July 23, 2021

RE: **Lot 6 Block 4 Unit 22 SAD 228
6408 Papagayo Rd. NW
Volcano Cliffs Subdivision
Revised Grading and Drainage Plan
Engineers Stamp Date 5/20/2021 (D10D003D6)**

DRAINAGE AND TRANSPORTATION INFORMATION SHEET (REV 6/2018)

ENGINEER'S SEAL	LOT 6 BLK 4 UN 22 VC 6408 PAPAGAYO ROAD, N.W.	DRAWN BY DEM
	GRADING AND DRAINAGE PLAN	DATE 5-19-20
		Lot 6 Blk 4 Un 22 VC -DWG
5/20/21	PO BOX 93924 ALBUQUERQUE, NM 87199 (505) 321-9099	SHEET # C1
DAVID SOULE P.E. #14522		JOB #

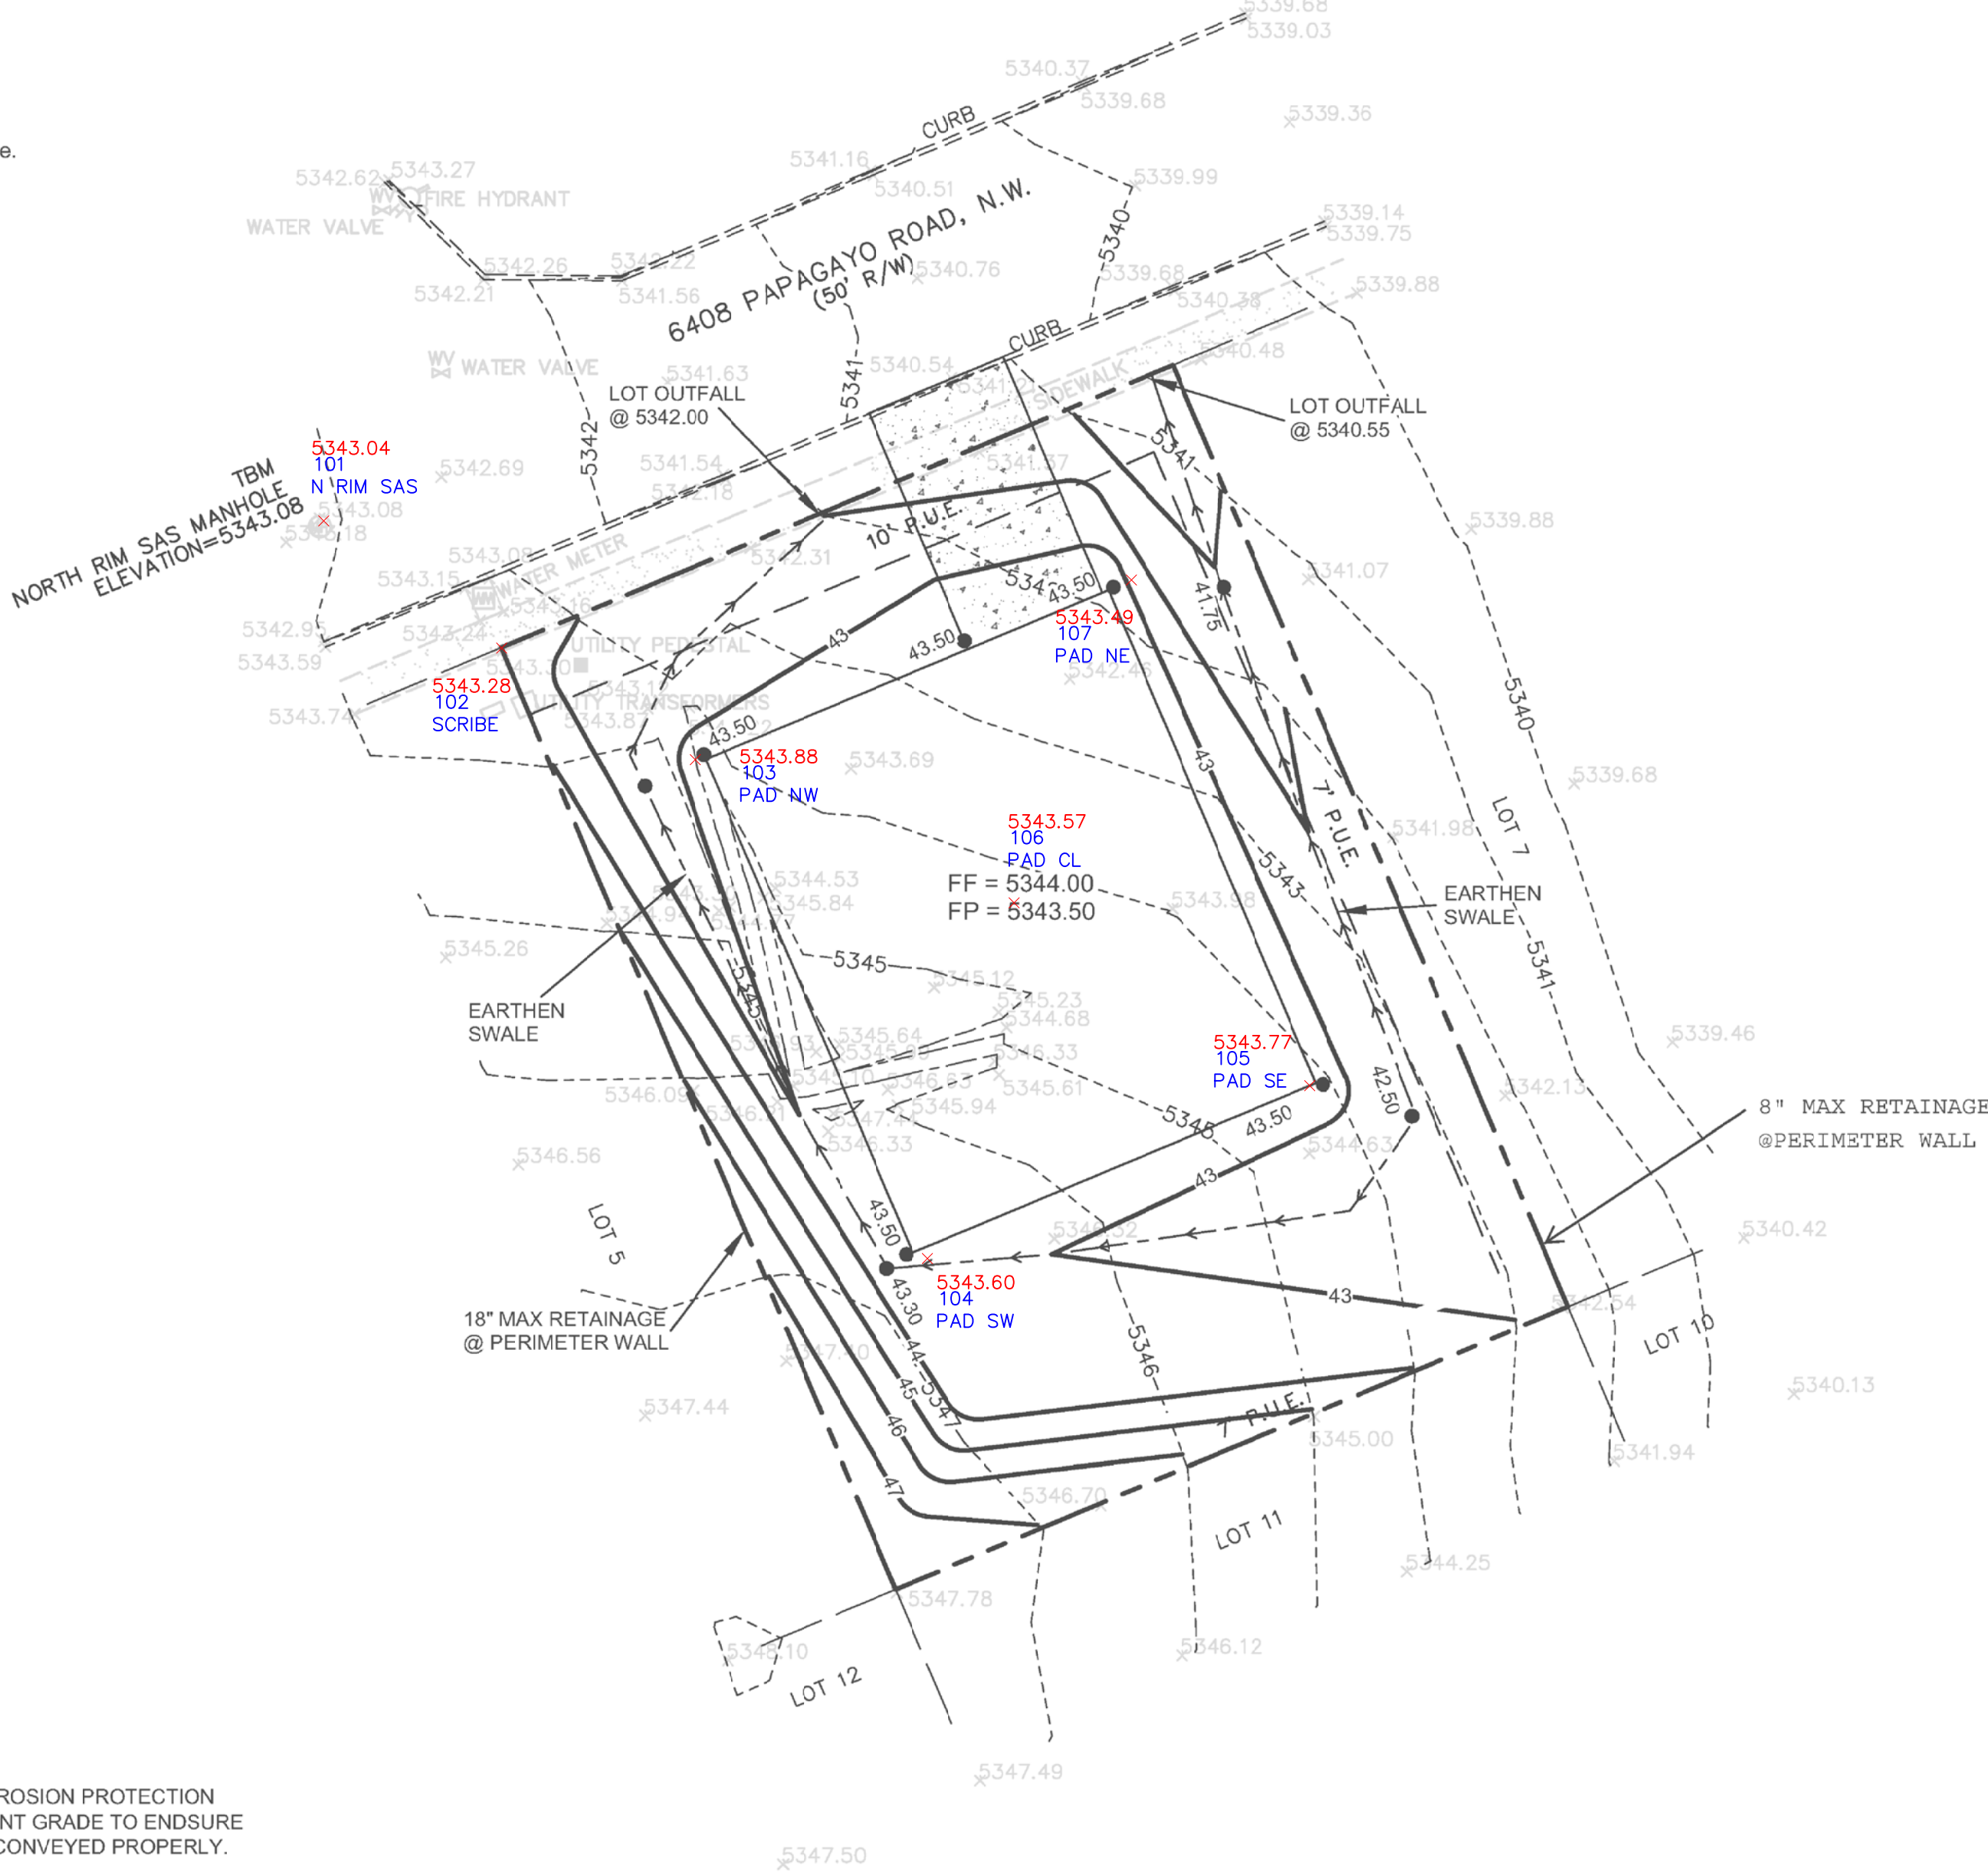
PO Box 1293
Based upon the information provided in your submittal received 7/21/2021, this plan is approved for Grading Permit. This will now be the plan used going forward.

Albuquerque
Prior to Building permit approval a Pad Certification will be required, provided by the Engineer or a registered Land Surveyor.

NM 87103
Advise the owner contractor not to use dirt as a ramp to climb the curb, use lumber or crusher fines for this purpose.

www.cabq.gov
Reiterate to the Owner/Contractor that a separate permit for a garden/retaining wall must be obtained with the approved G&D plan and Pad Certification. Also, if a swimming pool is to be placed after this approval a new grading and drainage plan will need to be resubmitted showing the changes for the land treatments.

Prior to Certificate of Occupancy release, Engineer Certification per the DPM checklist is required.
